LINCOLN/LANCASTER COUNTY PLANNING STAFF REPORT

P.A.S.: Waiver of Design Standards #01020

PROPOSAL: To waive the lot width to depth ratio as required by the Land Subdivision Ordinance Section 26.21.140(a) on two lots in a proposed administrative final plat.

RE: CYRILLA COURT THIRD ADDITION - ADMINISTRATIVE FINAL PLAT
WAVIER OF DESIGN STANDARDS - LOT DEPTH TO WIDTH RATIO

1 of 1

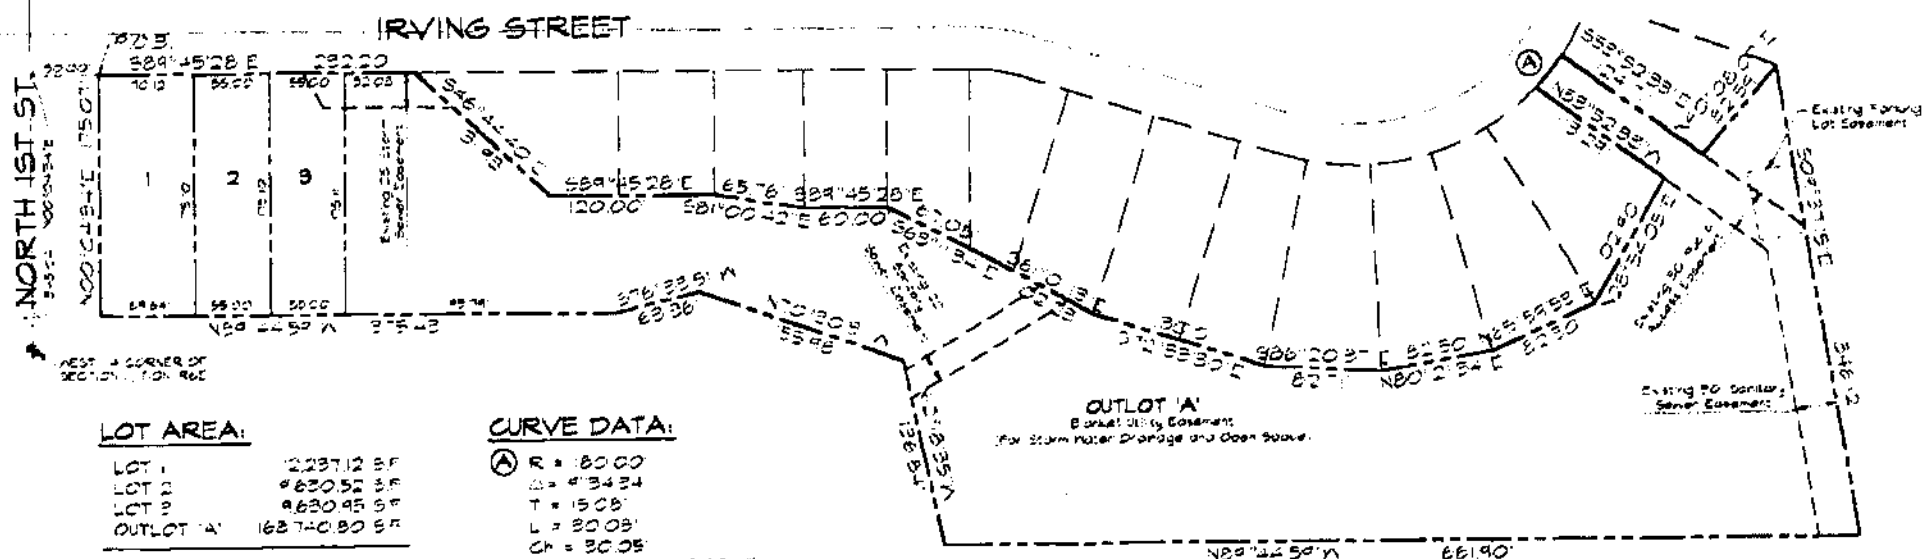
CONCLUSION: The 3 to 1 lot depth to width ratio requirement is difficult to meet due to the adjacent drainage channel and the distance between Irving Street and the south limits of the subdivision. The lot depth is ten feet too deep to meet the 3:1 ratio requirement.

1. This is an application for a waiver of design standards to allow two lots that do not meet the lot depth to width ratio as required by the Land Subdivision Ordinance Section 26.21.140(a).
2. Cyrilla Court 3rd Addition is an administrative plat for three lots. It is difficult for two of the lots to meet the requirement due to adjacent drainage channel and the distance between Irving Street and the south limits of the subdivision. Action on the administrative plat must wait until action has been taken on this waiver of design standards.
3. The Public Works & Utilities Department does not object to the waiver.
4. The lot depth is ten feet too deep to meet the 3:1 lot depth to width requirement.

We are requesting a wavier of design standards for the lot width to depth ratio. We are only requesting the wavier on Lots 2 and 3. Lot 1 does not require the wavier because it meets the width to depth ratio.
